**Report: TAB REPORT**  
**Function: Test, Adjust, & Balance**  
**Date: 07/19/2023**

## 06-26-23 CARMAX #7179 - MILWAUKEE, WI

## Issue List

**RTU-9connected  
08/31/2023**

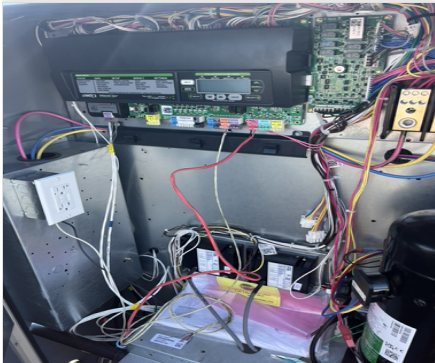
**Issue Name :** DI Smoke is not Landed in RTU-10  
**Description :** DI Smoke input is not connected in RTU-10. Unsure of reason, left disconnected. Recommend service.  
**Created By :** National TAB                      **Assigned To :** National TAB - Michael McDonnell  
**Status :** Open  
**Originated Date :** 08/31/2023 - Michael McDonnell - National TAB

# PART PLAN – HVAC

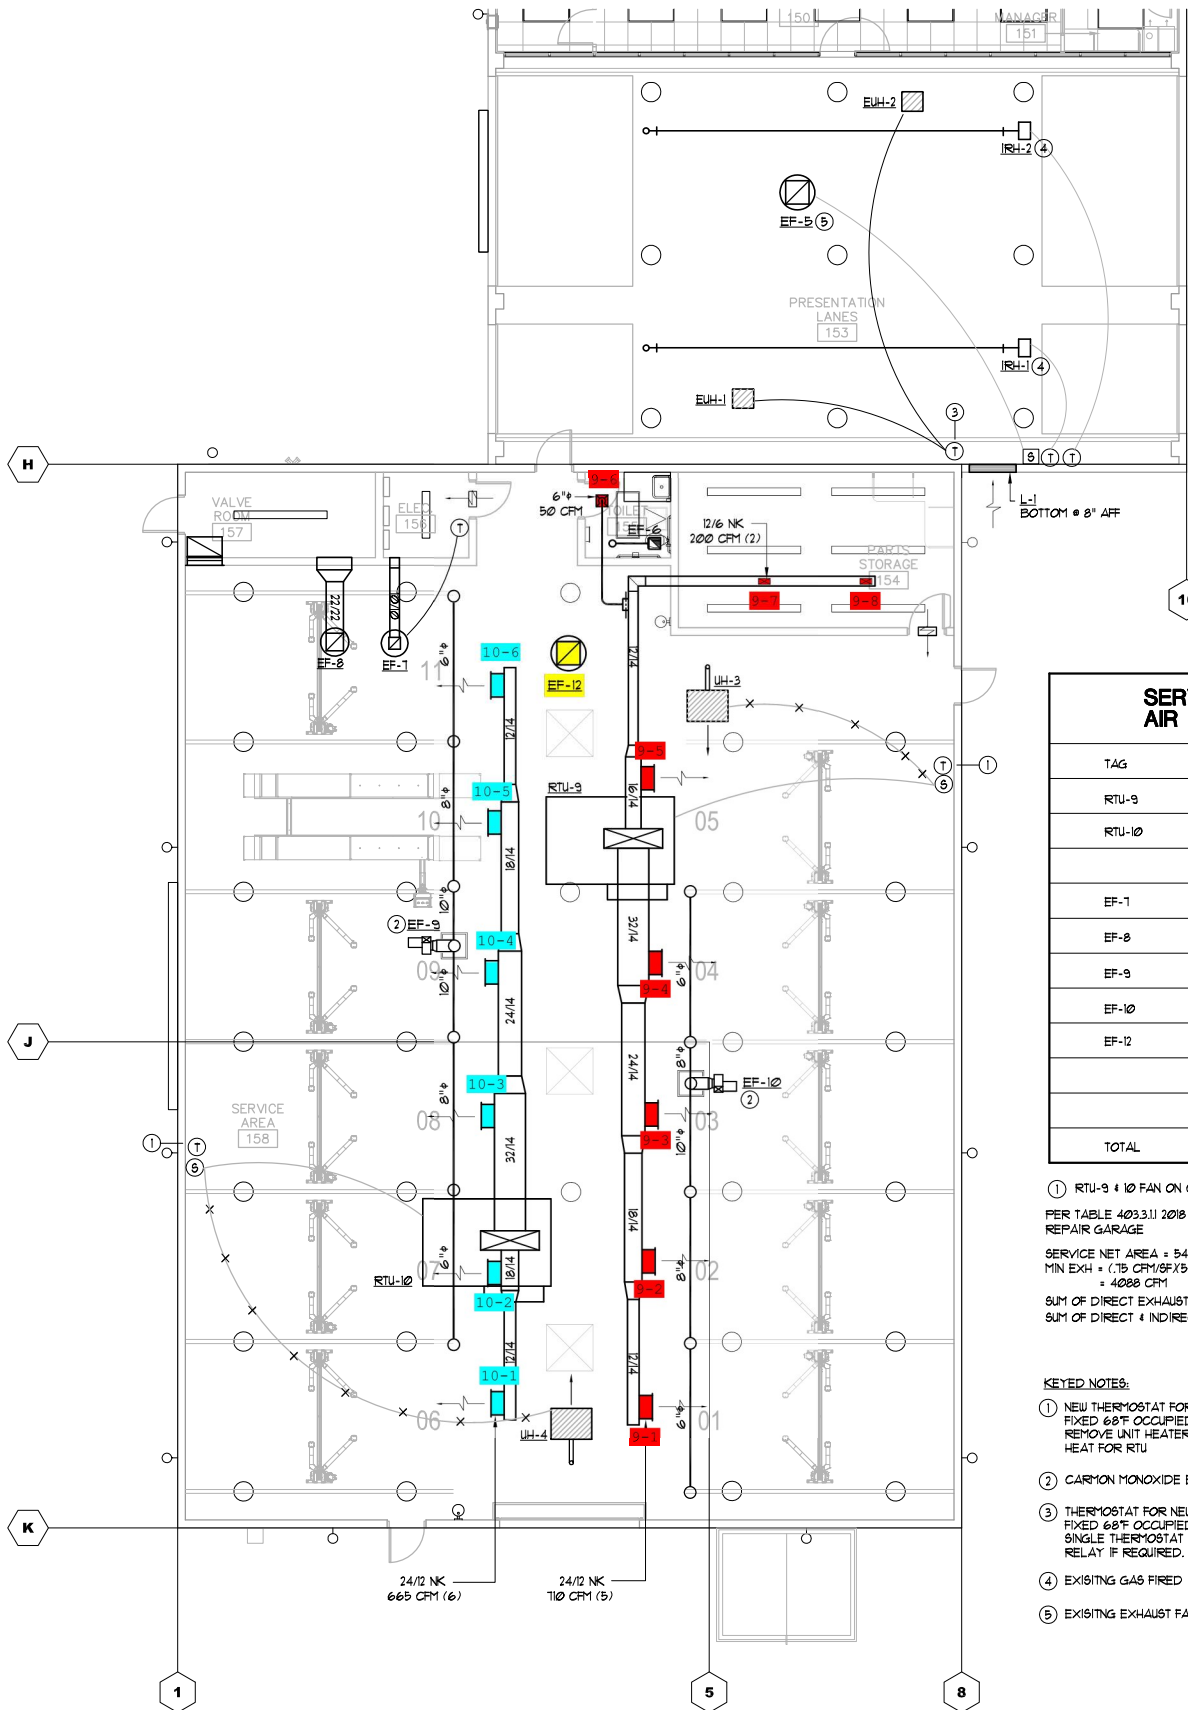
**Issue Name :** EF-12 High On Airflow  
**Description :** EF-12 measured at 2,037 CFM. Unable to decrease flow. Currently a single speed fan. Recommend having a speed controller installed.  
**Created By :** National TAB **Assigned To :** National TAB - Dylan Crisman  
**Status :** Open  
**Originated Date :** 06/29/2023 - Dylan Crisman - National TAB

[1] UNABLE TO SLOW FAN TO DESIGN W/O SPEED CONTROL.
